GROUP	MODEL
ELE	2018-2022MY Stinger (CK)
NUMBER	DATE
255	June 2022

TECHNICAL SERVICE BULLETIN

DYNAMIC BENDING LIGHT DTC B232509/B232609 - MOISTURE ABSORBENT & BRACKET REPLACEMENT

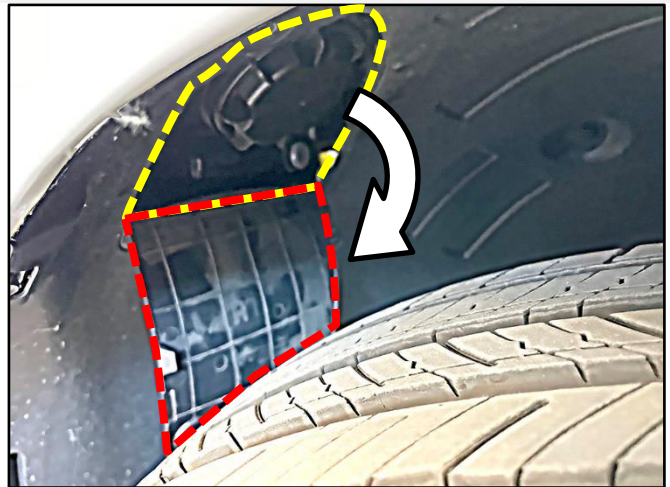
1. Replace the moisture absorbent and bracket on both sides with the new parts by referring to the "Body Electrical System → Lighting System → Headlamps → Repair procedures → Replacement → Moisture Absorbent" chapter in the applicable Shop Manual on KGIS.

Note: The service cover is located on the inner fender liner. Remove the clip at the top of the cover, then fold down as shown to access the dust cover.

Do **NOT** remove the rivets at the bottom of the service cover.

Even if only one of the DTCs is found (active or pending), the moisture absorbent and bracket must be replaced on BOTH sides.
